UNITED STATES PATENT AND TRADEMARK OFFICE

| APPLICATION NO. | FILING DATE | FIRST NAMED INVENTOR | ATTORNEY DOCKET NO. | CONFIRMATION NO. |
|-----------------|-------------|-------------------------------|---------------------|------------------|
| 10/823,195 | 04/12/2004 | Wayne Clifton Augustus Wright | 1182-24 | 4040 |

Office Action Summary

DETAILED ACTION

Fig. 4

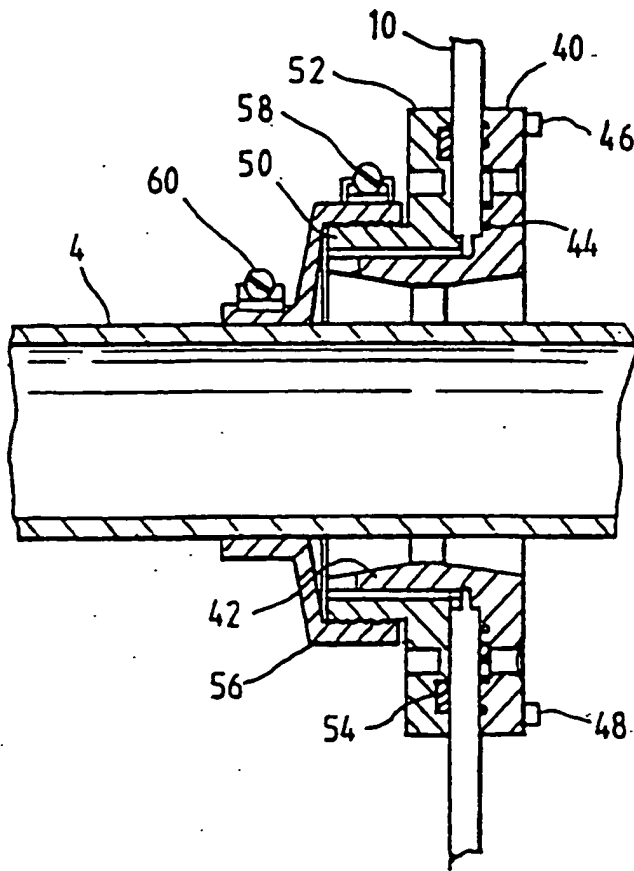
1. The drawings of figures 4 and 5 were received on 4/12/04 with the Preliminary Amendment. These drawings are approved.

approved
XN
10/14/04
